UNECE Software Update - General Diagnostic Requirements - Errata CRC

F-LAH UNECE-SU v1.2 bug list and its correction

Technical development, cross-sectional load booklet: LAH.DUM.905.E - Errata CRC

First edition	07.04.2021
Change status	10.06.2021
Specification version	1.0
Baseline	4.6 ()

Figure 3-1 Decision tree RID 0x0544

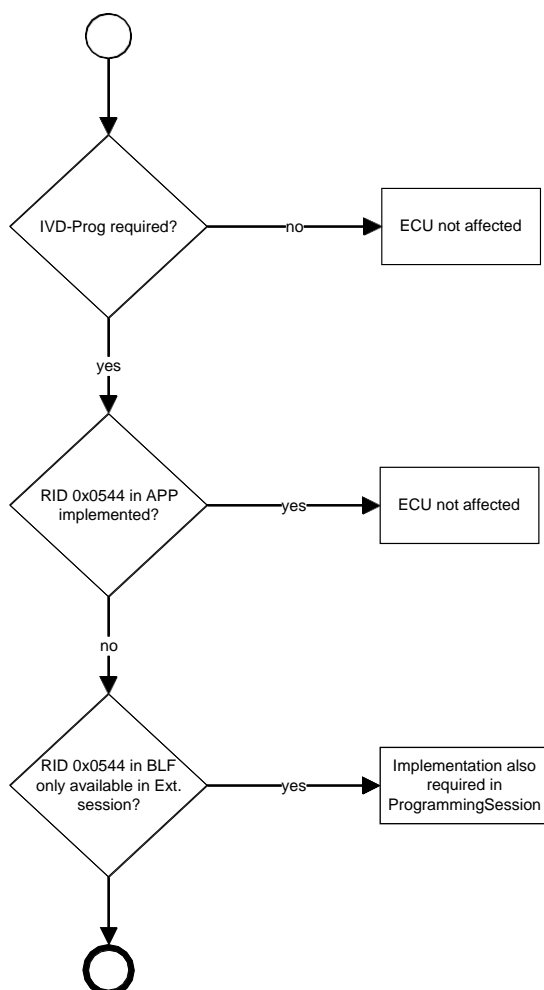
The routine "0x0544-Verify_partial_software_checksum" must also be available in the bootloader in the "ECUPro-grammingSession (0x02)".

Contrary to document /6/ and document /2/, the routine "0x0544-Verify_partial_software_checksum" must be available in the application in the "DefaultSession (0x01)" and in the "ExtendedSession (0x03)". In the boot loader, the routine "0x0544-Verify_partial_software_checksum" must be available in the "ExtendedSession (0x03)".

Contrary to document /6/ and document /2/, the routine "0x544-Verify_partial-software_checksum" must be available in the application in the "DefaultSession (0x01)" and in the "ExtendedSession (0x03)". In the bootloader, the routine "0x0544-Verify_partial_software_checksum" must be available in the "ExtendedSession (0x03)" **and the ECUProgrammingSession (0x02).**
